Bike/Ped Map Comments

Roadway Map Comments

Other Written Comments

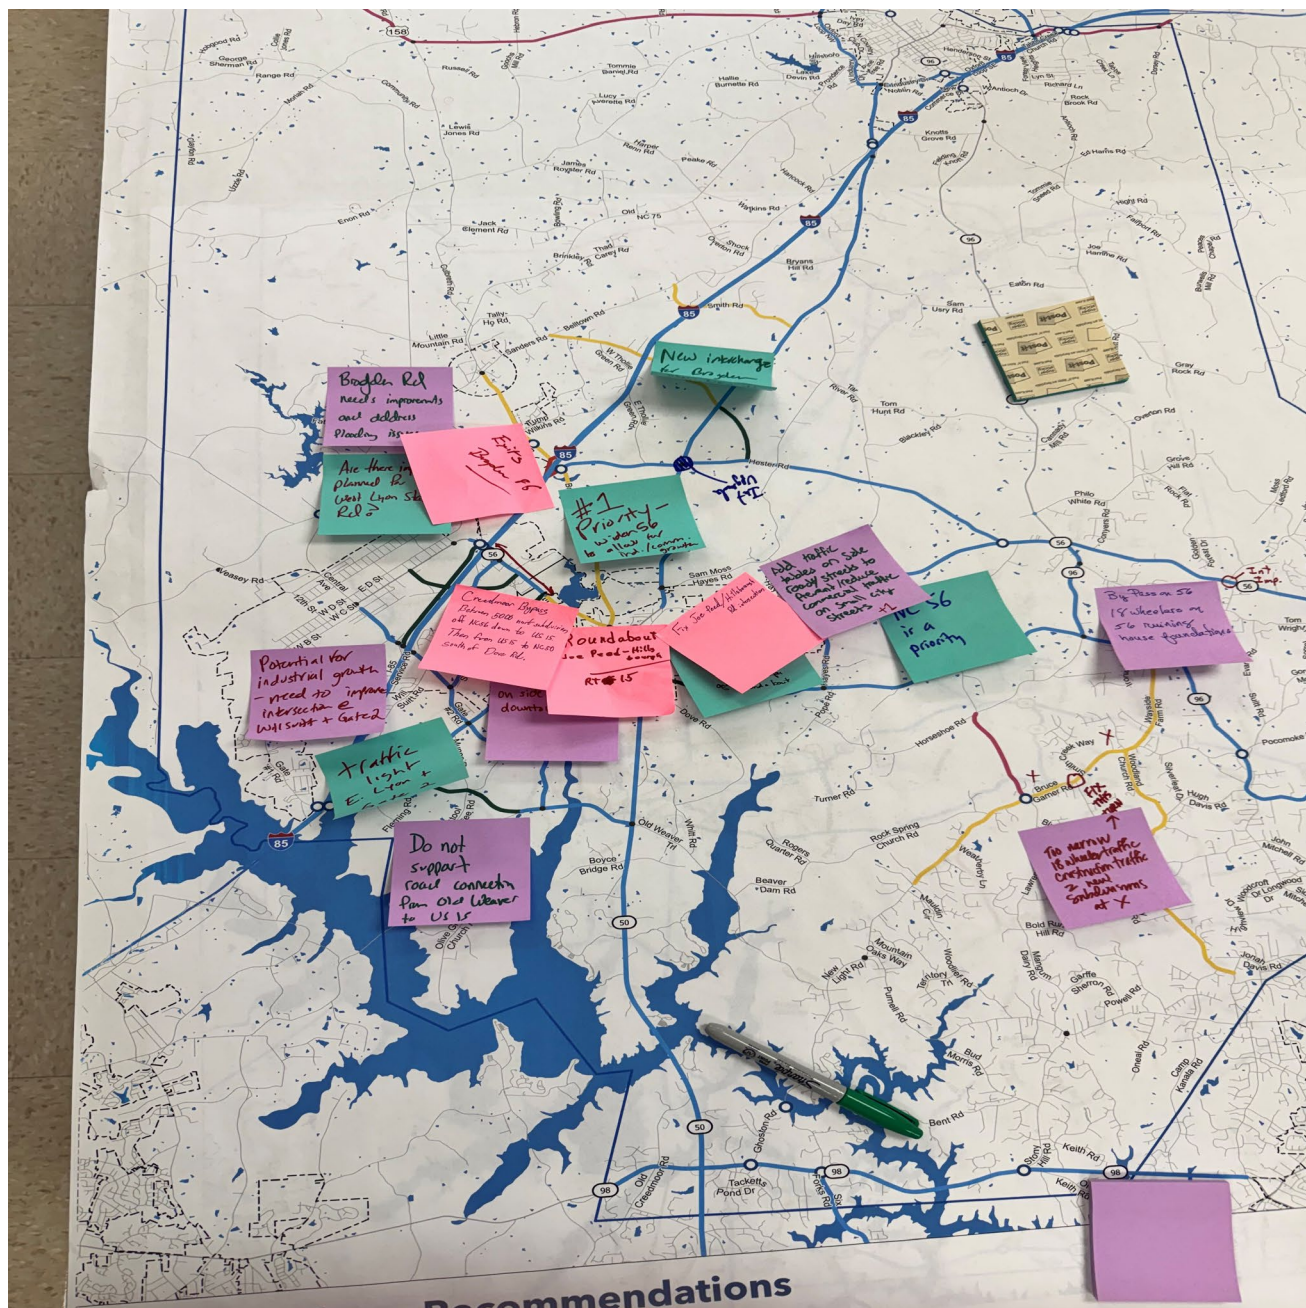
Look at
San Moss
Hayes
not all should
be heavy IND

The land use recommendations are a guide for how towns should develop land in the future following community input. It is unlikely that parcels will be zoned exactly as we designed them and the decision will ultimately be made by towns and municipalities.
